DESIGN DOCUMENTS
TEMPORARY TRAFFIC CONTROL

Project
SFPW 1000015860 PAUL AVE, WOOLSEY ST AND SALINAS AVE PAVEMENT RENOVATION AND SEWER REPLACEMENT

Sheet Title
TEMPORARY TRAFFIC CONTROL PLAN FOR ASPHALT GRIND & PAVE ON PAUL AVE AND SALINAS AVE – SHEET 4 OF 19

Sheet
TCP–063

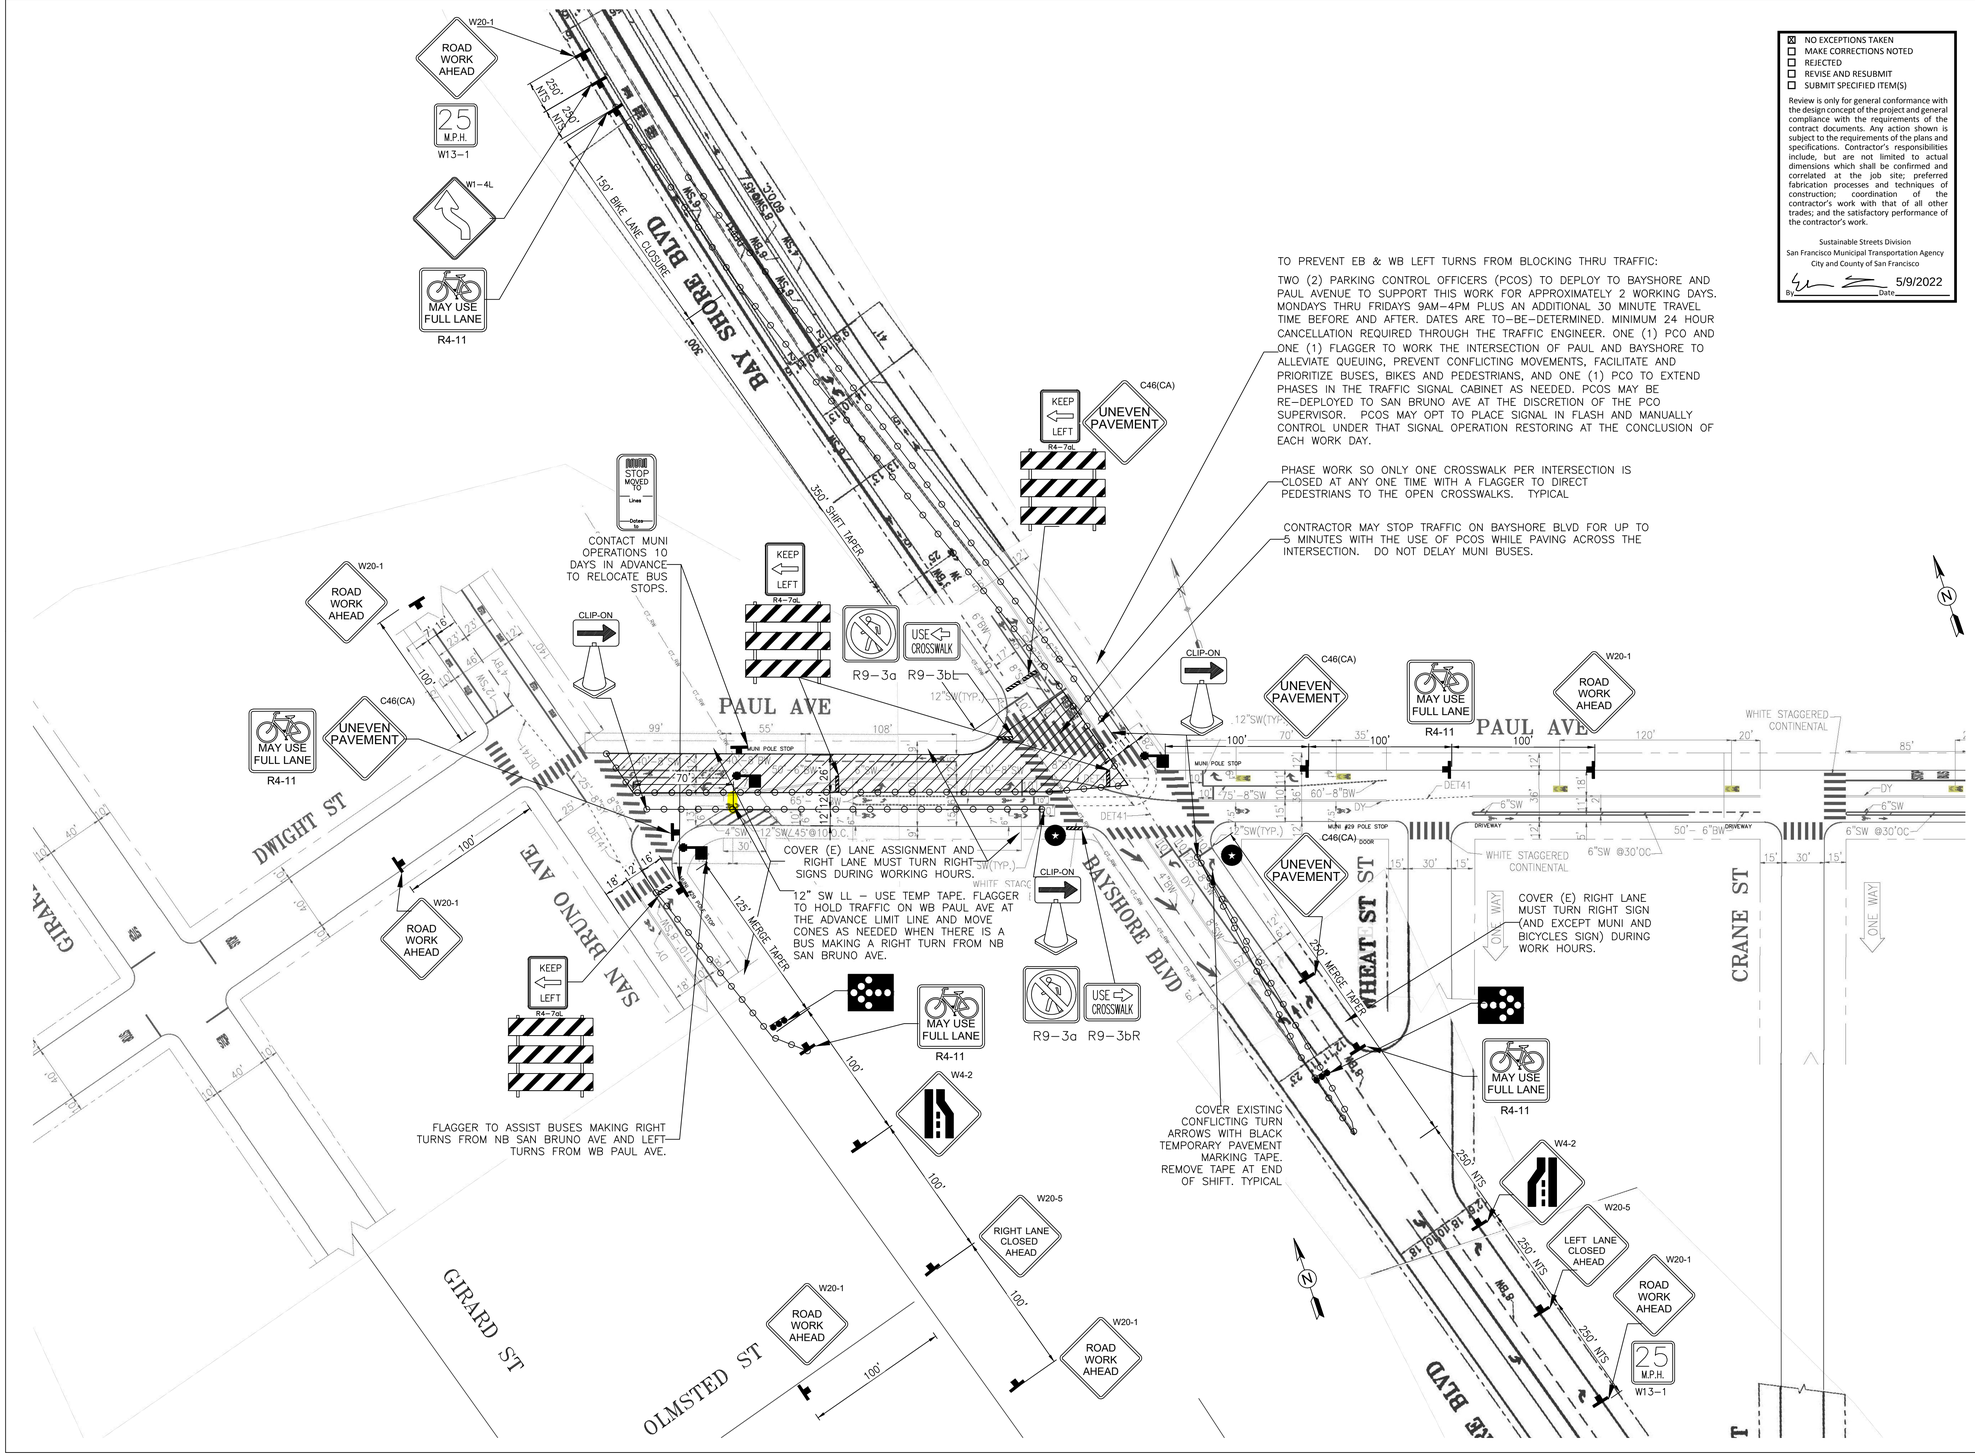
TO PREVENT EB & WB LEFT TURNS FROM BLOCKING THRU TRAFFIC:

TWO (2) PARKING CONTROL OFFICERS (PCOS) TO DEPLOY TO BAYSHORE AND PAUL AVENUE TO SUPPORT THIS WORK FOR APPROXIMATELY 2 WORKING DAYS. MONDAYS THRU FRIDAYS 9AM–4PM PLUS AN ADDITIONAL 30 MINUTE TRAVEL TIME BEFORE AND AFTER. DATES ARE TO–BE–DETERMINED. MINIMUM 24 HOUR CANCELLATION REQUIRED THROUGH THE TRAFFIC ENGINEER. ONE (1) PCO AND ONE (1) FLAGGER TO WORK THE INTERSECTION OF PAUL AND BAYSHORE TO ALLEVIATE QUEUING, PREVENT CONFLICTING MOVEMENTS, FACILITATE AND PRIORITIZE BUSES, BIKES AND PEDESTRIANS, AND ONE (1) PCO TO EXTEND PHASES IN THE TRAFFIC SIGNAL CABINET AS NEEDED. PCOS MAY BE RE–DEPLOYED TO SAN BRUNO AVE AT THE DISCRETION OF THE PCO SUPERVISOR. PCOS MAY OPT TO PLACE SIGNAL IN FLASH AND MANUALLY CONTROL UNDER THAT SIGNAL OPERATION RESTORING AT THE CONCLUSION OF EACH WORK DAY.

PHASE WORK SO ONLY ONE CROSSWALK PER INTERSECTION IS CLOSED AT ANY ONE TIME WITH A FLAGGER TO DIRECT PEDESTRIANS TO THE OPEN CROSSWALKS. TYPICAL

CONTRACTOR MAY STOP TRAFFIC ON BAYSHORE BLVD FOR UP TO 5 MINUTES WITH THE USE OF PCOS WHILE PAVING ACROSS THE INTERSECTION. DO NOT DELAY MUNI BUSES.

☒ NO EXCEPTIONS TAKEN
☐ MAKE CORRECTIONS NOTED
☐ REJECTED
☐ REVISE AND RESUBMIT
☐ SUBMIT SPECIFIED ITEM(S)
